GENERAL

This addendum forms a part of the Contract Documents and modifies the original Bidding Documents dated February 2024 and consists of pages AD1-1 through AD1-3, PSSB Data As-Built and PSSB RCP As-Built. The following changes, additions and/or deletions shall be made to the following documents; all other conditions shall remain the same.

ITEM NO. I – RFI/CLARIFICATIONS

PATIENT SUPPORT SERVICES BUILDING
 UCD PROJECT NO. A/C 934990

5 THIRD FLOOR REFLECTED CEILING PLAN

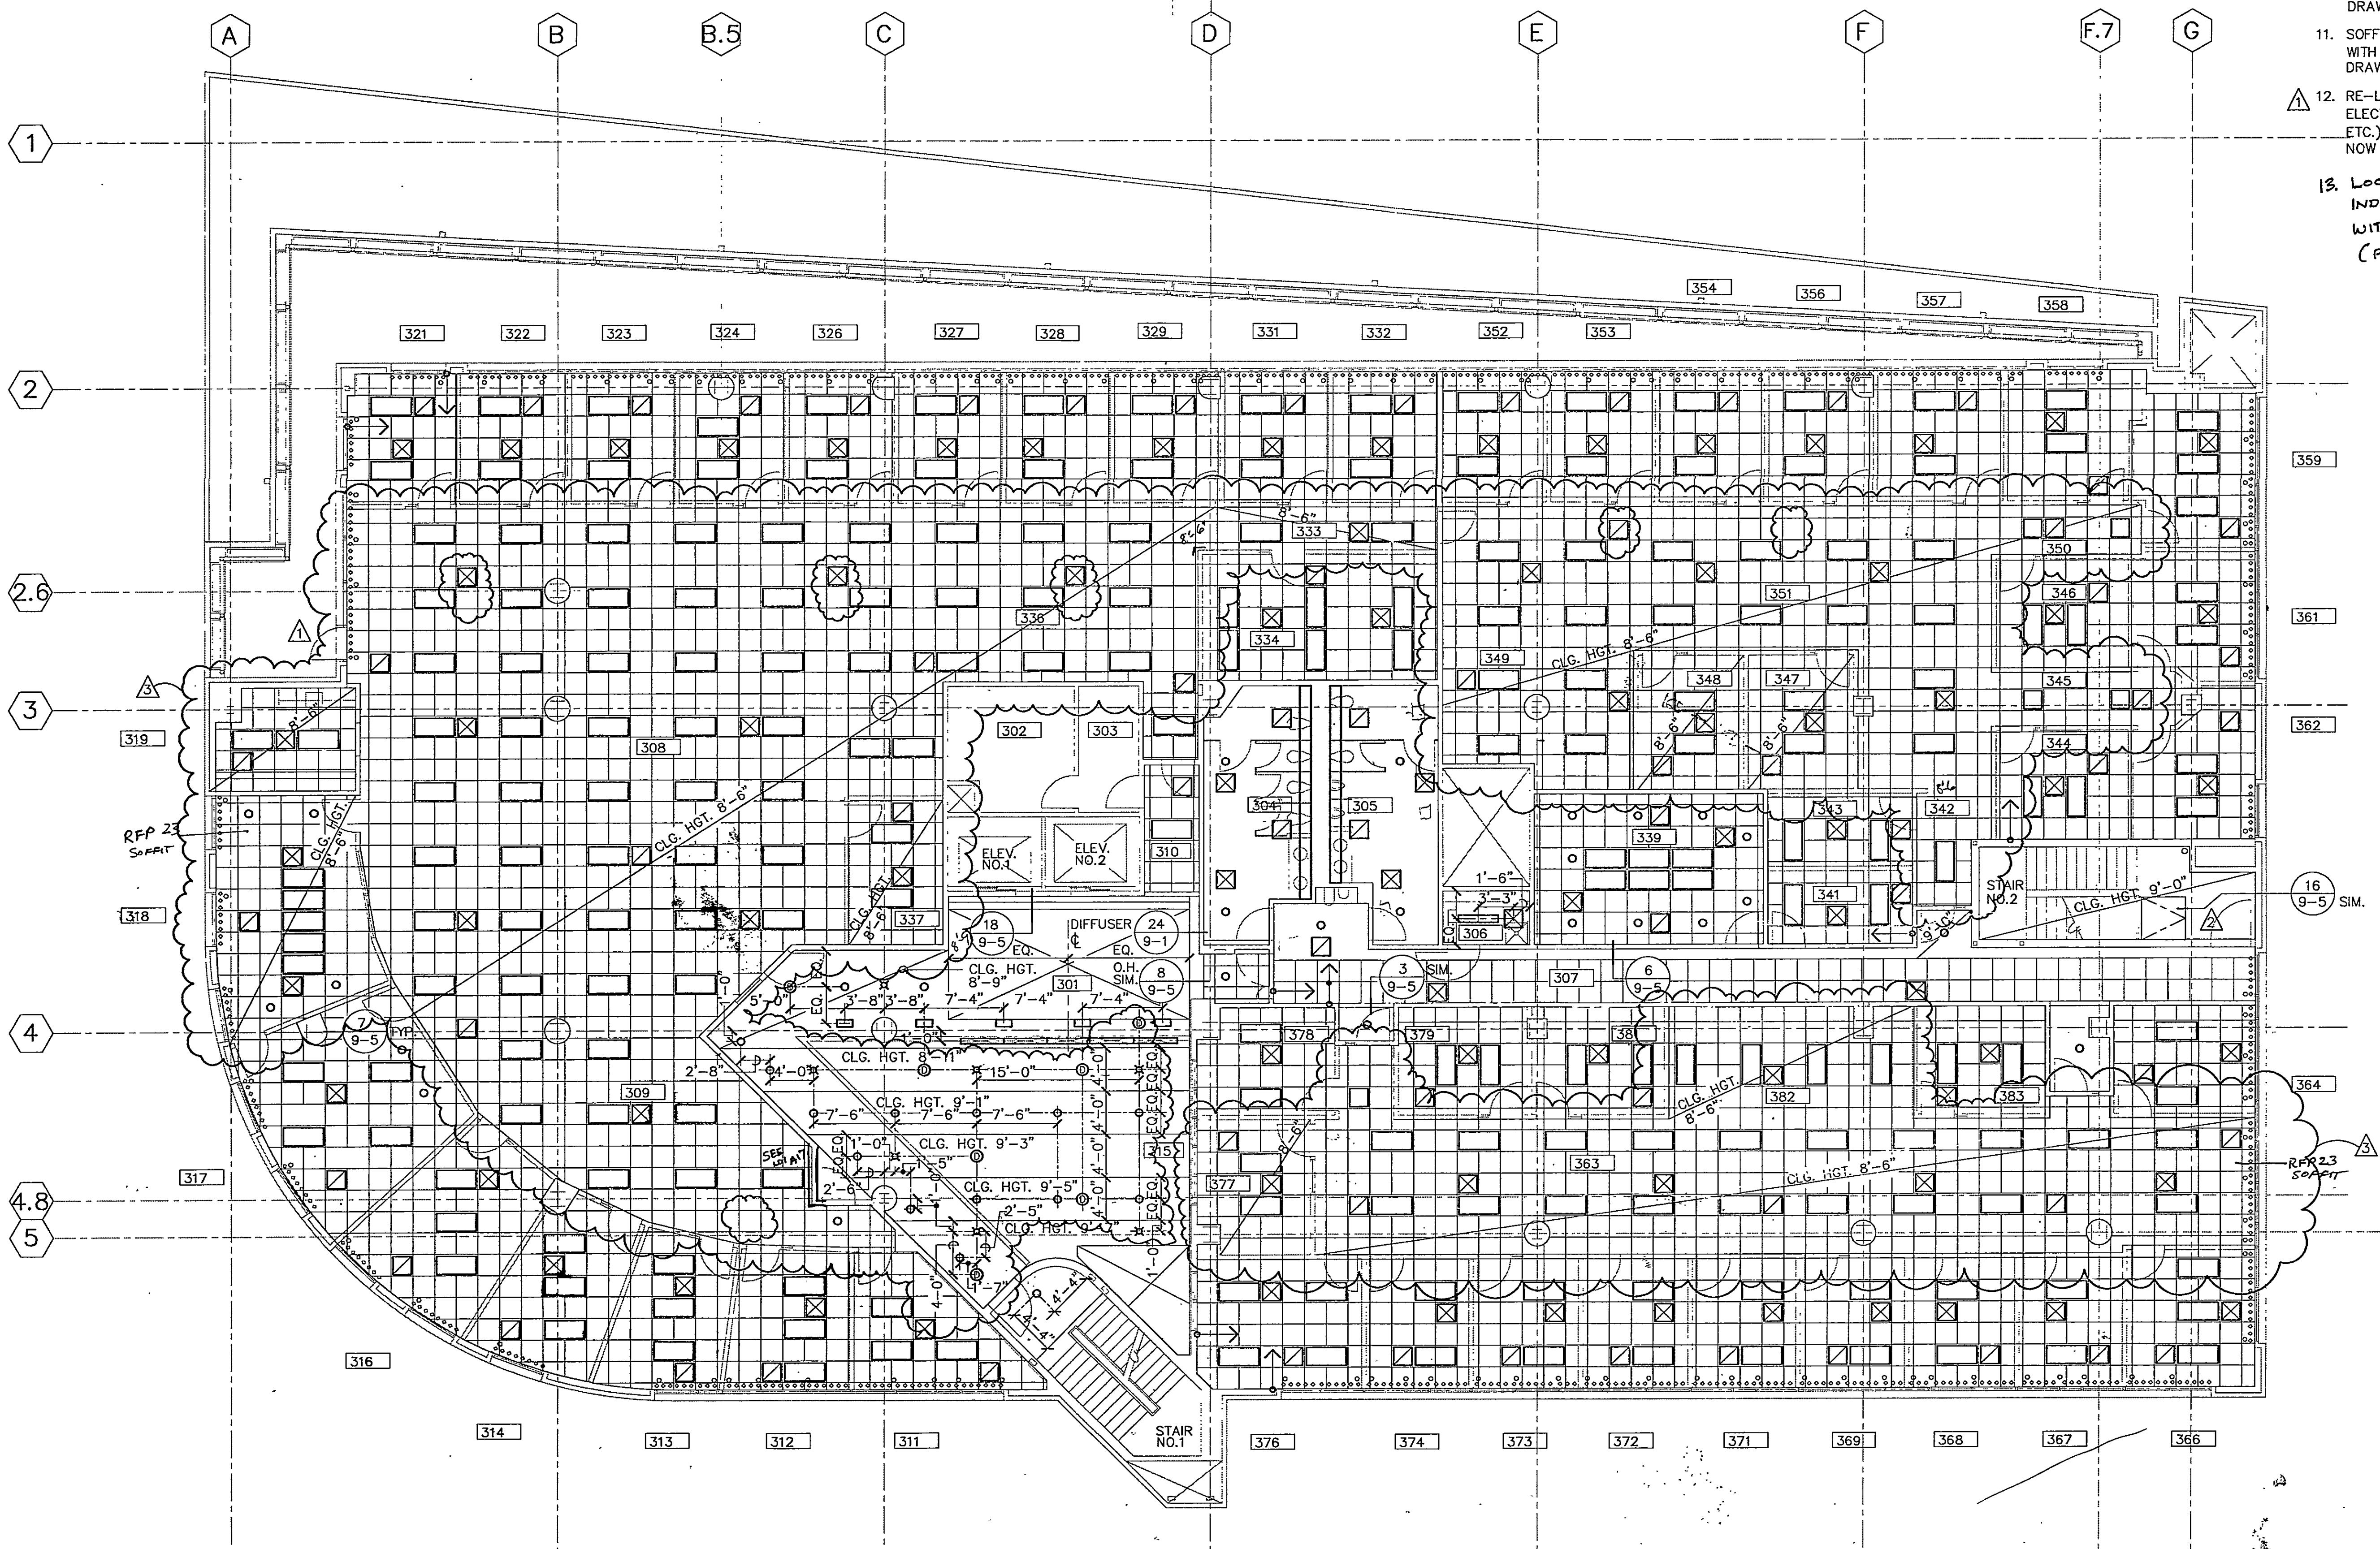
17. **Question:** Please confirm the ceilings on each floor are drop tiles in the areas where we will be required to access the ceiling.

18. **Question:** Please confirm the ceiling height on each floor is not higher than 15'.

Answer: See attached as built reflected ceiling plans. There are limited areas where a hard lid ceiling is present.

Answer: Confirmed. Caveat being the entryway atrium space. See reflected ceiling plan as built files for to reference extent of atrium space.
